Re: Glendale Hydroelectric Project (FERC No. 2801-MA);
Updated Run-of-River and Minimum Flow Monitoring and Compliance Plan.

Minimum Flow Unit General Arrangement

MINI-HYDRO CONCEPT A
UNIT LAYOUT PLAN

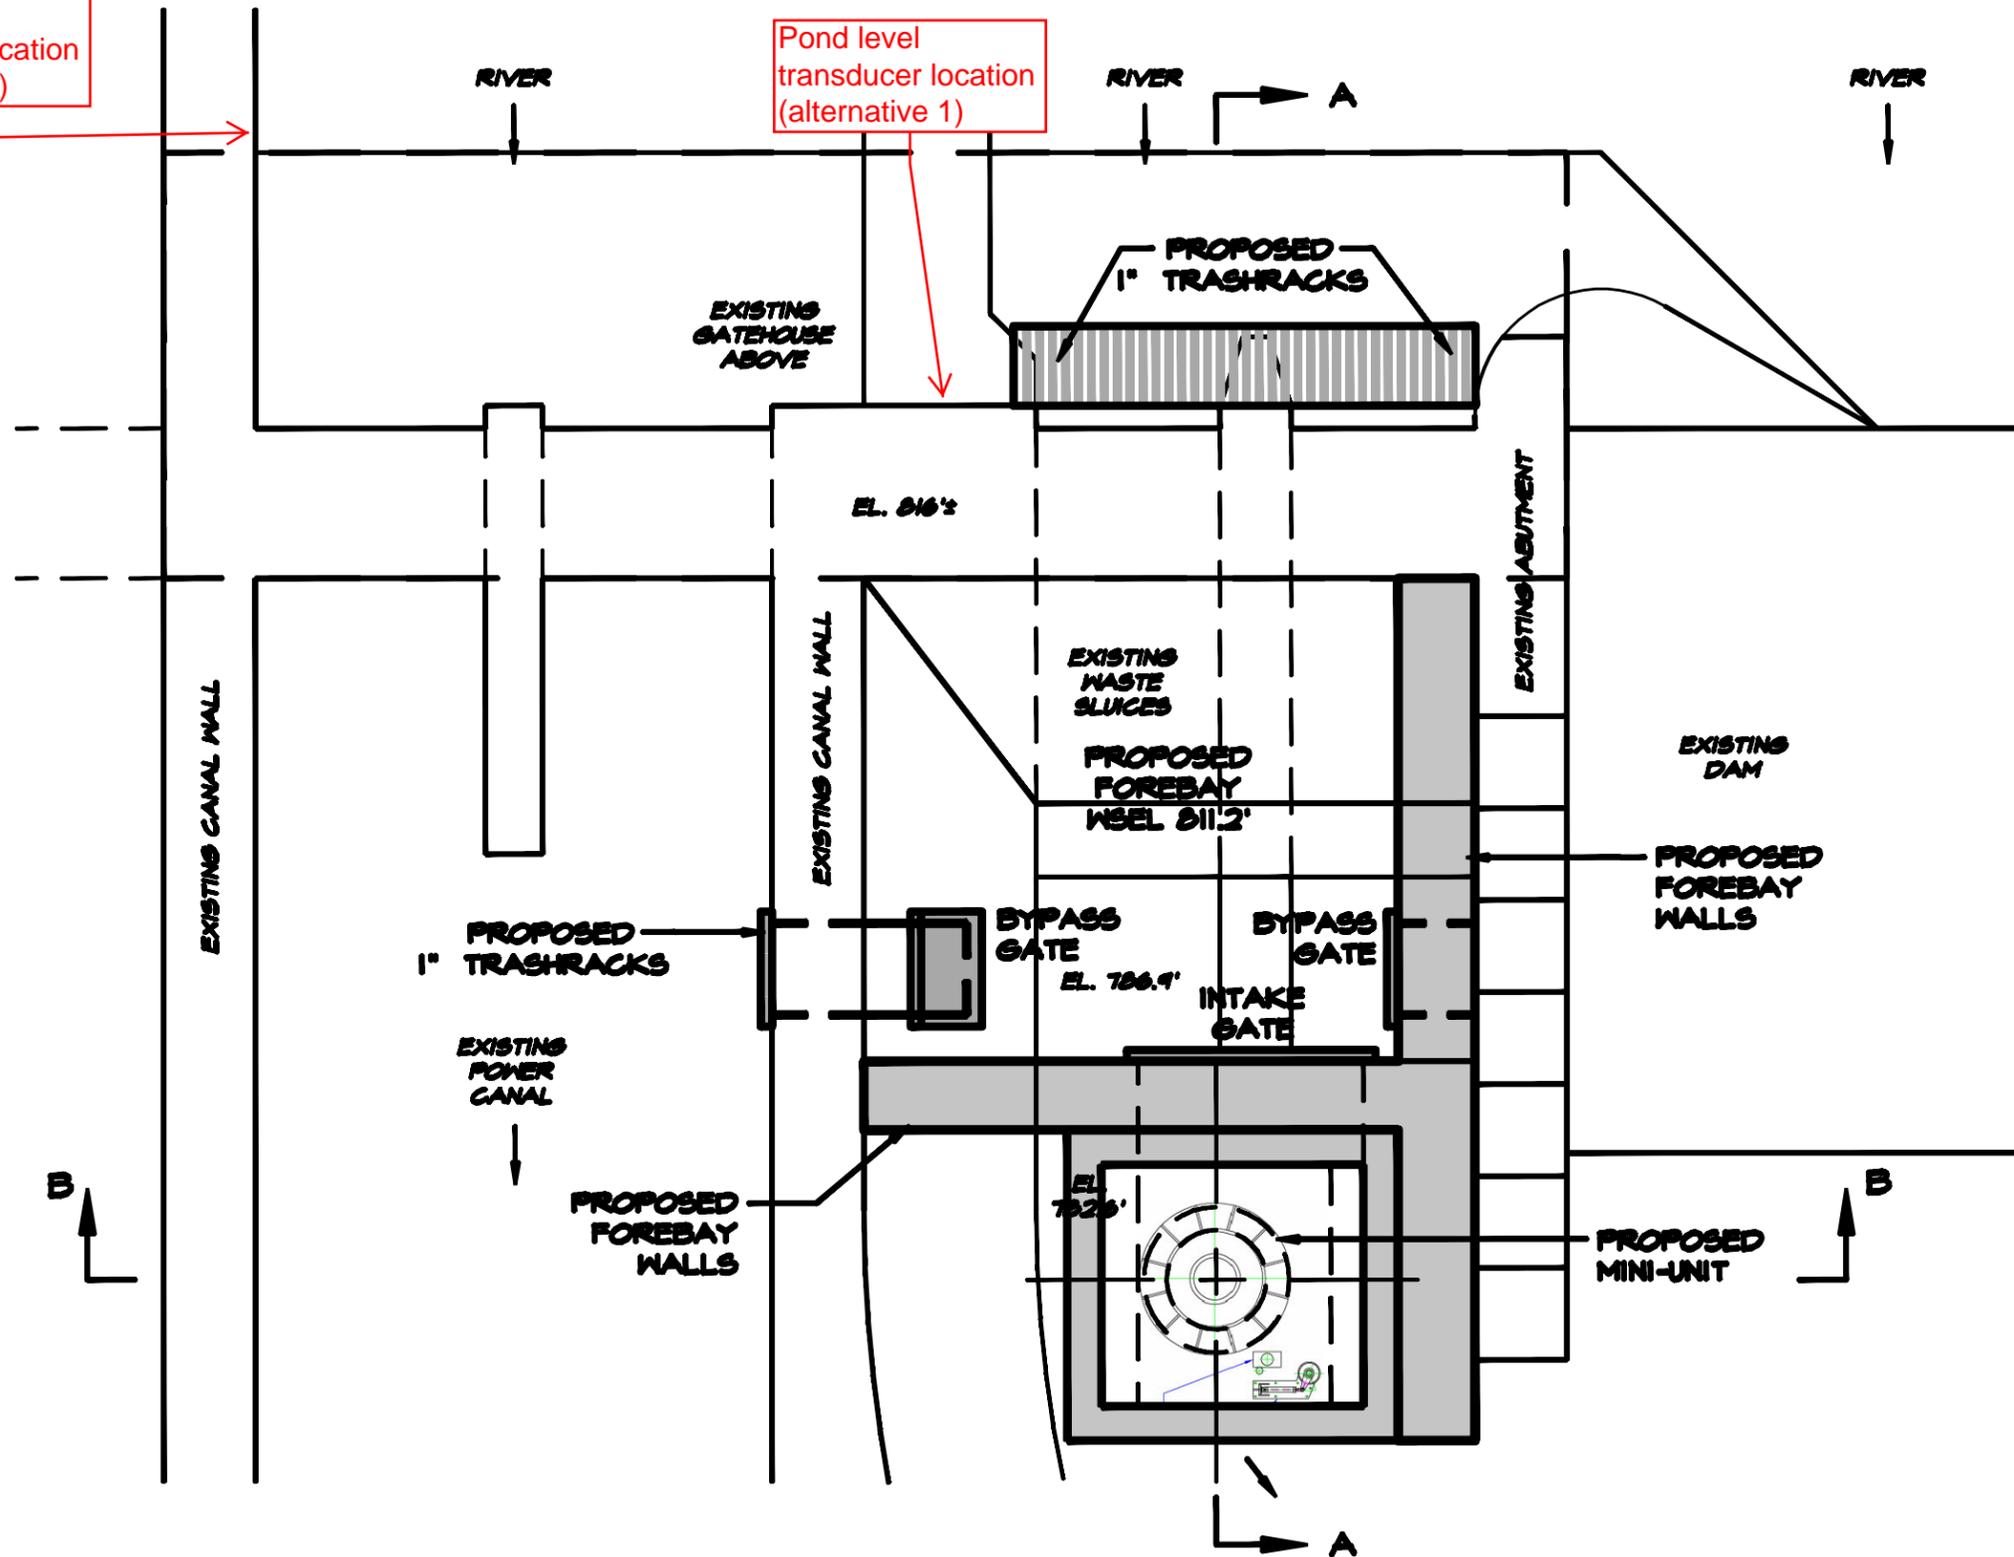
- *it would be helpful to include a plan-view drawing of the project that delineates the headpond, gatehouse, new forebay and associated structures, and the location of the headpond sensor.*

A plan view of the gatehouse showing the above features is provided in Attachment A.
